TOWN AND COUNTRY PLANNING ACT 1990 CONSULTATION RETURN: DC/23/1157/FUL

PROPOSAL: Planning application - (a) three dwellings (b) visitor parking (c) boundary treatments (d) new section of public footpath (f) relocation of street light

LOCATION: Land At Rose Bank Burton End Haverhill Suffolk

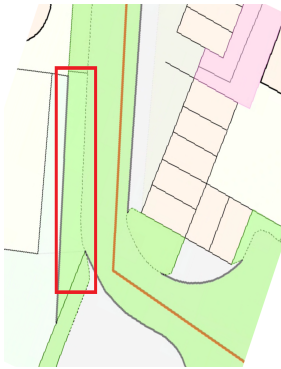
Visibility Splays - denote in full.

For a 30mph road, in absence of speed surveys, SCC would require 2.4 x 43m visibility splays. However, if a traffic survey was completed and the recorded 85th %ile speeds were just under 30mph a sight stopping distance lower than 43m would be appropriate.

Pedestrian visibility splays measuring 2 x 2 meters are to be provided within land under the applicants control.

Land ownership

Clarification should be provided for the area marked in red SCC records show this as land maintainable highways expense. The details within the application have it denoted as ownership of Haverbury Housing.

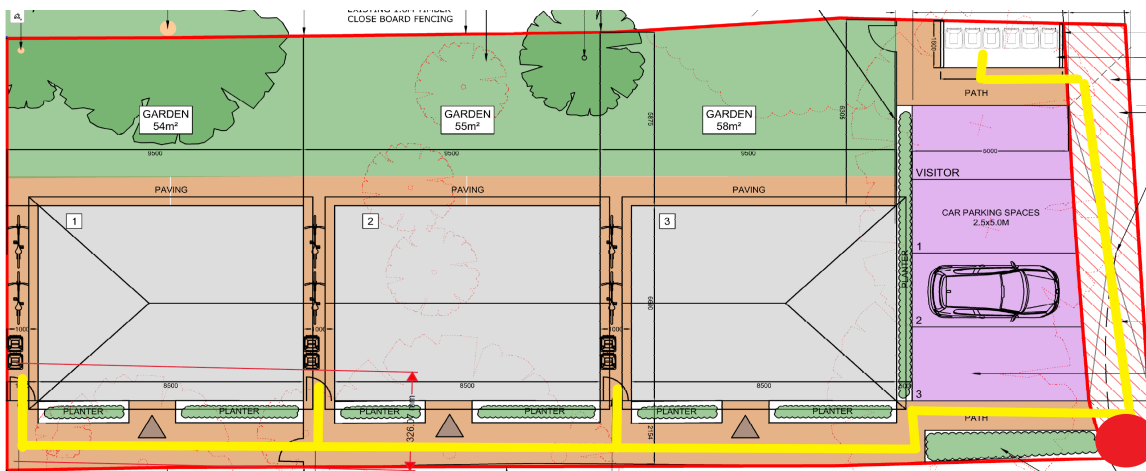
The proposed location of bin storage is unacceptable and obstructs safe passage to and from the rear of the properties.

The required distance from the properties to the bin presentation area may be considered excessive, specifically for those with mobility issues. From Plot 1 an approximate distance of 55 meters is required. Yellow line.

The bin presentation area is disconnected from the proposed route to the bin storage, this requires the resident to drag bins to the opposing corner of the site. As such it would not be considered unreasonable to assume bins would be presented at the path within the footpath rather than the designated presentation area. Red dot.

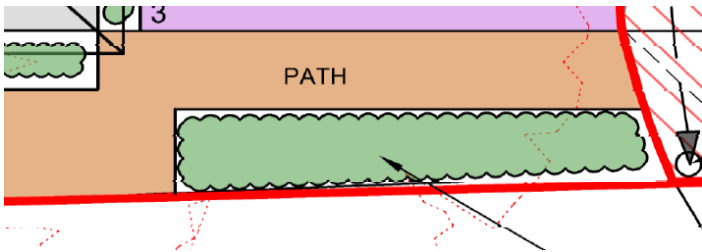
The proposed hedging creates 90 degree s-bend configuration that may be detrimental to the movements of wheeled users.

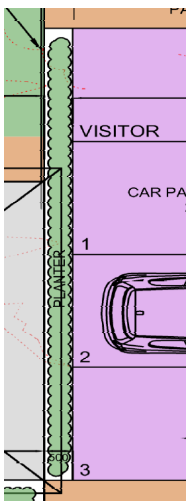
Parking spaces of 5 x 2.5 meters are to be provided, there is a planter proposed to the rear of the spaces. It would not be unreasonable to assume that depending on the planting these plants may grow to a size that vehicles cannot appropriately park in a manor that does not obstruct the highway, it is suggested this is removed.

Are the parking bays 1, 2, 3 and visitors to be allocated? Please update the drawing and design and access statement to reflect this this wording.
